LIC-12-0120  
August 24, 2012

**SUBJECT: Responses to Requests for Additional Information Re: License Amendment Request 10-07 to Adopt NFPA 805, "Performance-Based Standard for Fire Protection for Light Water Reactor Generating Plants," 2001 Edition, at Fort Calhoun Station**

**RESPONSES TO REQUESTS FOR ADDITIONAL INFORMATION RE:  
LICENSE AMENDMENT REQUEST TO ADOPT NATIONAL FIRE PROTECTION  
ASSOCIATION STANDARD 805, "PERFORMANCE-BASED STANDARD FOR FIRE  
PROTECTION FOR LIGHT WATER REACTOR GENERATING PLANTS," 2001 EDITION  
FORT CALHOUN STATION, UNIT NO.1  
DOCKET NO. 50-285**

**Figure R-5 from NUREG/CR-6850**

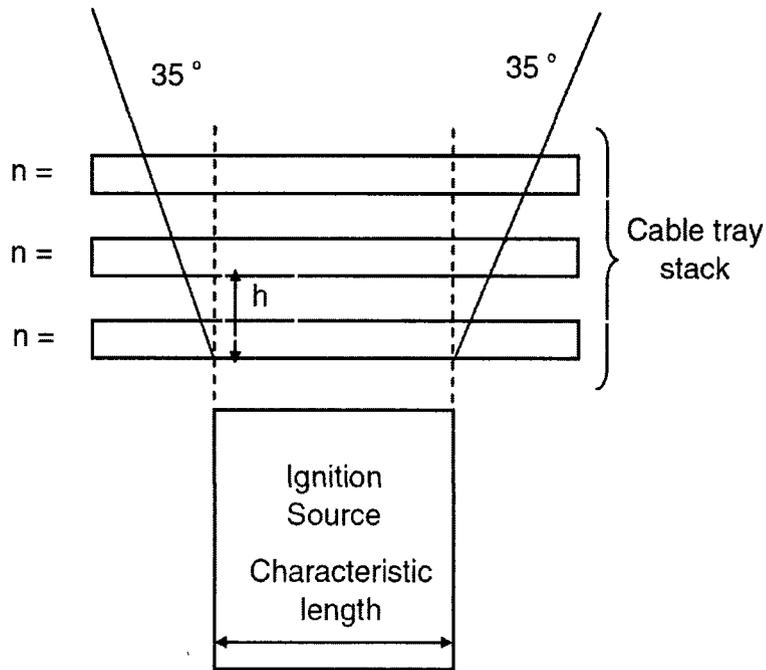
- c. **Please explain how the HRR of cable tray fires was calculated. Please provide justification for the use of a "characteristic length" of 1 foot instead of the cabinet length as specified in NUREG/CR-6850, "EPRI/NRC-RES, Fire PRA Methodology for Nuclear Power Facilities," page R-9, and explain (i.e., a sensitivity study to obtain a quantitative measure) the effect of this discrepancy on the ZOI and HGL calculations and target damage assessment. In addition, please provide a justification for the fact that the effect of the cable tray fire on the radius of the ZOI was not considered.**

As the fire propagates to each subsequent tray, it is assumed to spread at an angle of 35 degrees per the following figure (taken from Section R.4.2 of NUREG/CR-6850):

As fire propagates to each tray, the tray burning surface area is calculated based on the 35-degree spread. The HRR contribution of each tray is calculated based on its burning surface area and the HRR equation presented above.
